Entergy Operations, Inc.
1448 S R 333
Russellville, AR 72801
Tel 501-858-4888

1CAN040302

April 2, 2003

SUBJECT: Arkansas Nuclear One, Unit 1 (ANO-1)
Docket No. 50-313
License Amendment Request to Modify the Fuel Assembly
Enrichment, the Spent Fuel Pool (SFP) Boron Concentration Technical
Specification (TS) 3.7.14, the Loading Restrictions in the SFP in TS
3.7.15, and to Modify the Fuel Storage Design Features in TS 4.3

Figure 3.7.15-1
Burnup-versus-Enrichment-Curve-for
Spent-Fuel Storage Racks
**MINIMUM BURNUP VS. INITIAL ENRICHMENT
FOR REGION 2 STORAGE**

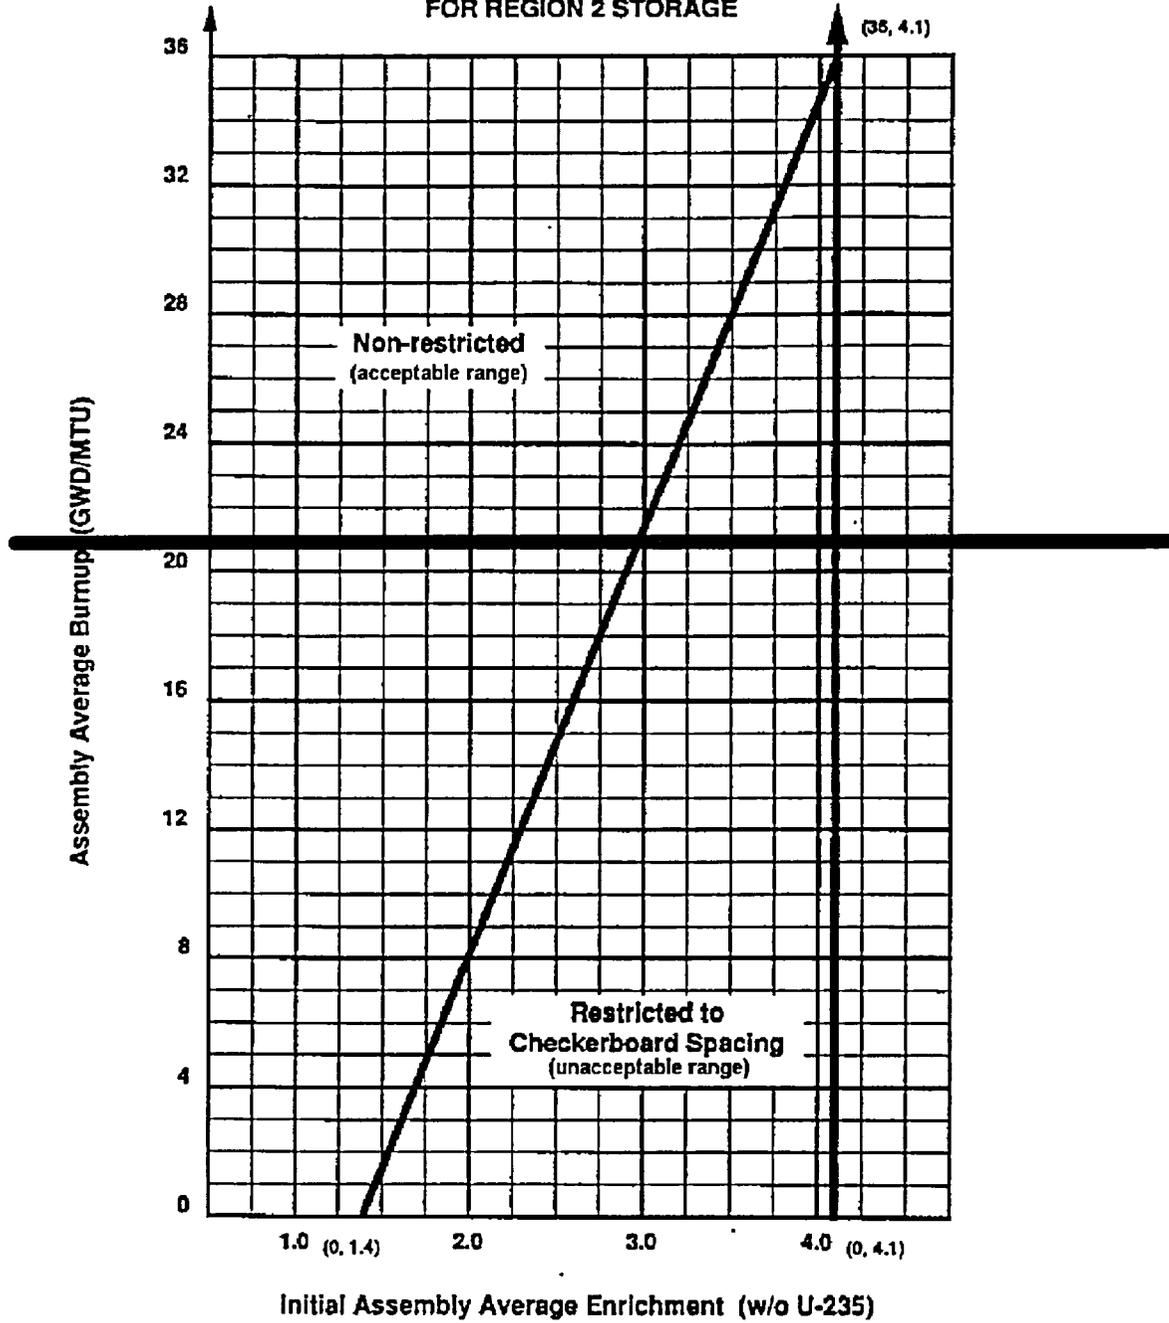
ANO-1 TS 3.7.15 and Figure 3.7.15-1 define loading restrictions for any fuel assembly that is stored in Region 2 of the ANO-1 SFP. Currently, no loading restrictions are required by TS in SFP Region 1, which allows storage of new and spent fuel. Region 1 contains Boraflex® poison panels. Calculations indicate that the Boraflex® content in Region 1 will degrade below the original Boraflex® content assumed in the criticality analysis (Reference 2). Based on continued projected degradation of Boraflex®, the proposed change will take no credit for Boraflex® in Region 1 and will include loading restrictions for Region 1. This will result in changes to TS 3.7.15 and Figure 3.7.15-1, and the creation of a new Figure 3.7.15-2 based on new criticality analysis for Regions 1 and 2. In addition, a portion of the SFP racks in Region 2 will be modified by the installation of Metamic® poison panel inserts. This will result in the creation of a new Region 3 that will allow unrestricted storage of new and spent fuel. Entergy has submitted a topical report (Reference 1) that describes the physical and chemical properties of Metamic®. Approval of the topical report is required to allow the use of Metamic® in SFP applications.

TS 3.7.15, Figure 3.7.15-1, TS 4.3.1.1.d, and TS 4.3.1.1.e currently define loading restrictions for Region 2 based on the combination of initial enrichment and burnup of each spent fuel assembly. The loading restrictions were defined by the approval of TS Amendment 76 (NRC Safety Evaluation Report (SER) dated April 15, 1983) which allowed modification of the ANO-1 SFP storage capabilities from 589 spaces to 968 spaces. The expansion was accomplished by

Figure 3.7.15-1
Burnup versus Enrichment Curve for
SFP Storage Racks Region 1

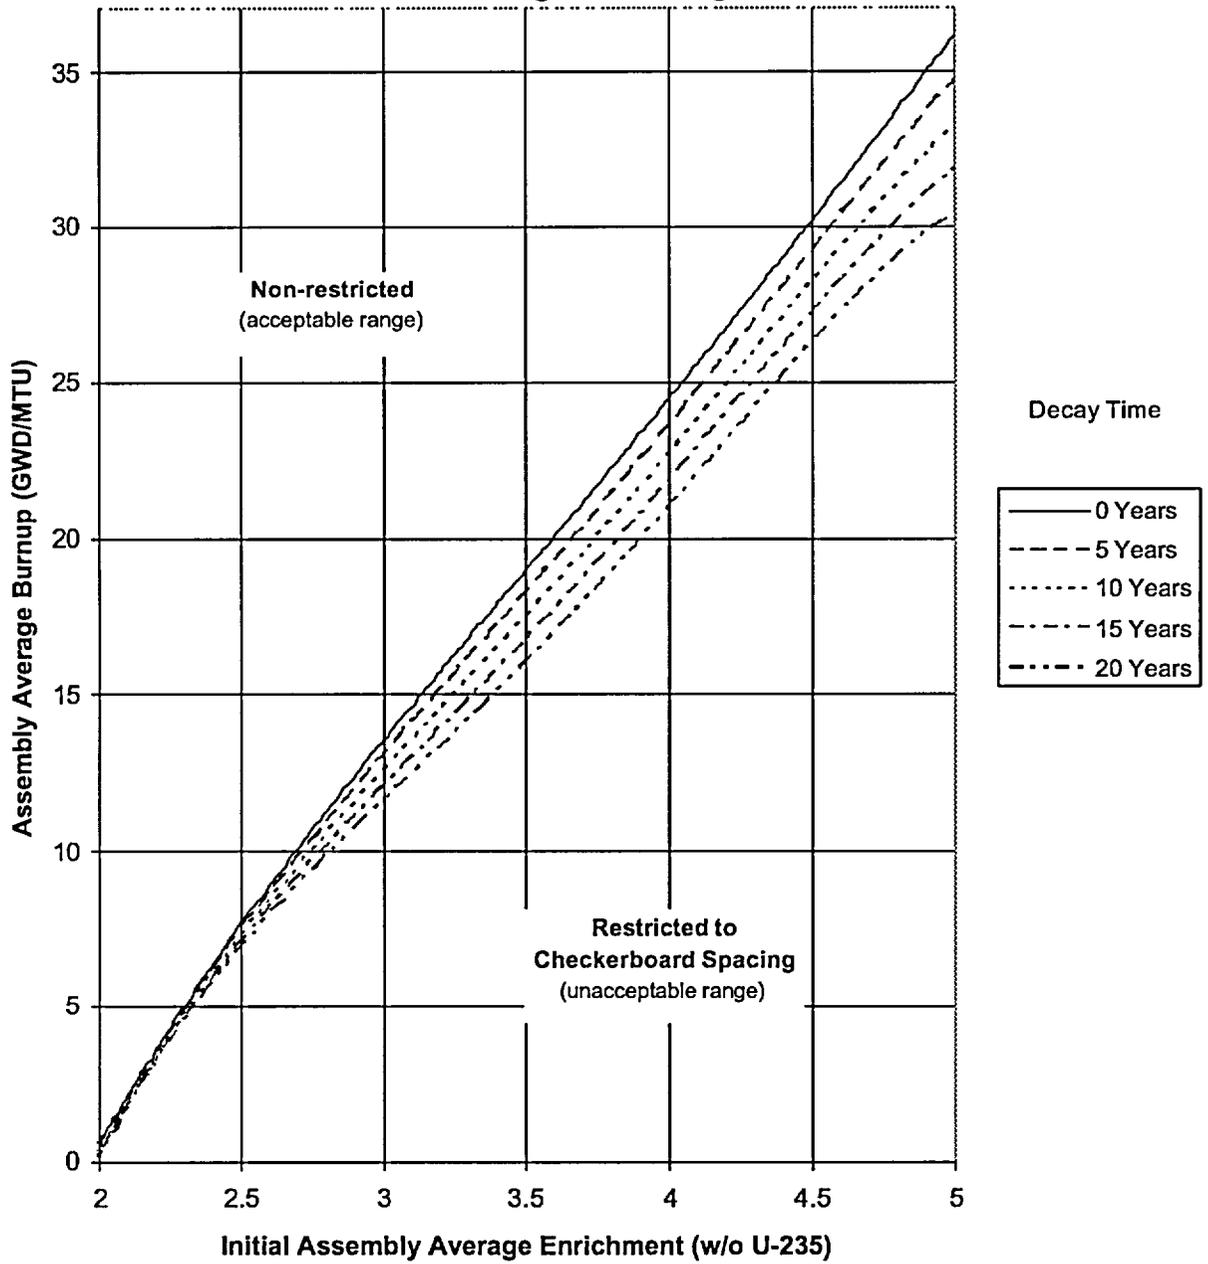
Fresh or spent fuel with enrichments up to 5.0 wt% U-235 may be stored in Region 1 and/or Region 2 per TS 3.7.15 Figures 3.7.15-1 (Region 1) and 3.7.15-2 (Region 2). The figures use initial U-235 enrichment and burnup to determine loading restrictions. The five curves on each figure represent decay time in years. Decay time is based on the time at which an assembly is permanently placed in the pool (i.e., if an assembly is placed in the pool one cycle and then returned to the core, the initial time in the pool is not included in the decay time once the assembly is permanently removed from the core.) The following equations were used to generate the decay curves and may be used to interpolate fuel placement in restricted or non-restricted regions:

Figure 4.10.2: Acceptable New Fuel Storage Vault Configuration for up to 4.95 wt% Enrichment Fresh Fuel

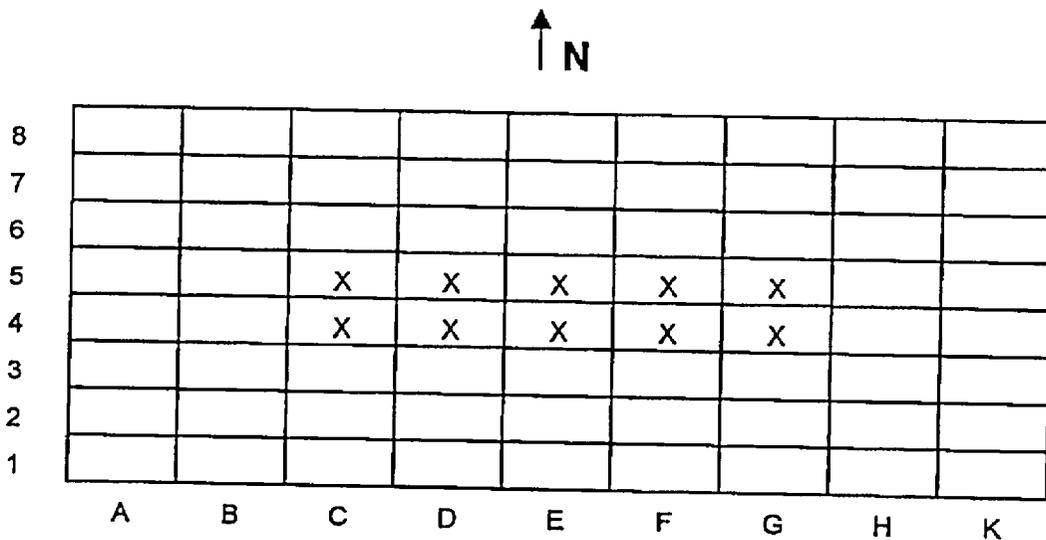
ANO-1 Figure 4.3.1.2-1 depicts locations in the fresh fuel storage racks in which fuel loading is prohibited. Based on the increase in fuel assembly enrichment from 4.1 w/o to a maximum enrichment of 5.0 w/o, two loading pattern configurations will be proposed, which will result in the addition of a new Figure 4.3.1.2-2. Figure 4.3.1.2-2 will depict the loading pattern associated with fuel assemblies whose enrichment is up to 4.2 w/o and Figure 4.3.1.2-1 will illustrate the loading configuration for fuel assemblies whose enrichment is up to 5.0 w/o. A change is also proposed to TS 4.3.1.2.d and e to state that the fuel storage racks shall be maintained in accordance with the two proposed figures which are based on fuel enrichment.

The New Fuel Storage Vault provides two 4 x 9 storage rack modules with cell array of storage locations arranged on a 21.00 inch lattice spacing. Calculations were made with the 238-group NITAWL KENO Va code package (SCALE 4.3), a three-dimensional Monte Carlo analytical technique, with fresh fuel assemblies with 4.95 wt% initial enrichment. These calculations were made for various moderator densities and the results shown in Figure 4.10 1, shows that the peak reactivity (optimum moderation) occurs at 9% moderator density. The calculations for the configuration illustrated in Figure 4.10.2 confirm that five locations in each of the storage racks are required to remain empty in order to meet the regulatory limits. Results of the criticality safety analyses are summarized in Table 4.10.1 for the two accident conditions for fuel assemblies of 4.95 ± 0.05 wt% initial enrichment. The maximum reactivity at

Figure 4.10.3: Acceptable New Fuel Storage Vault Configuration for up to 4.2 wt% Enrichment Fresh Fuel.

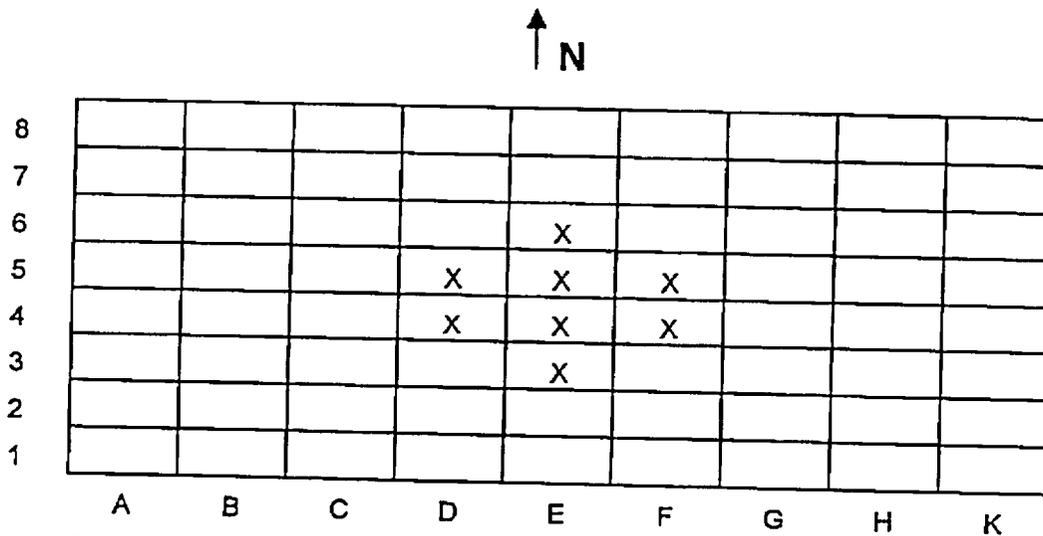
Additional calculations at 9% moderator density, performed for the storage pattern depicted in Figure 4.10.3, show that this storage configuration is acceptable for storage of fresh fuel assemblies of up to 4.20 wt% enrichment with four locations in each rack array required to remain empty.
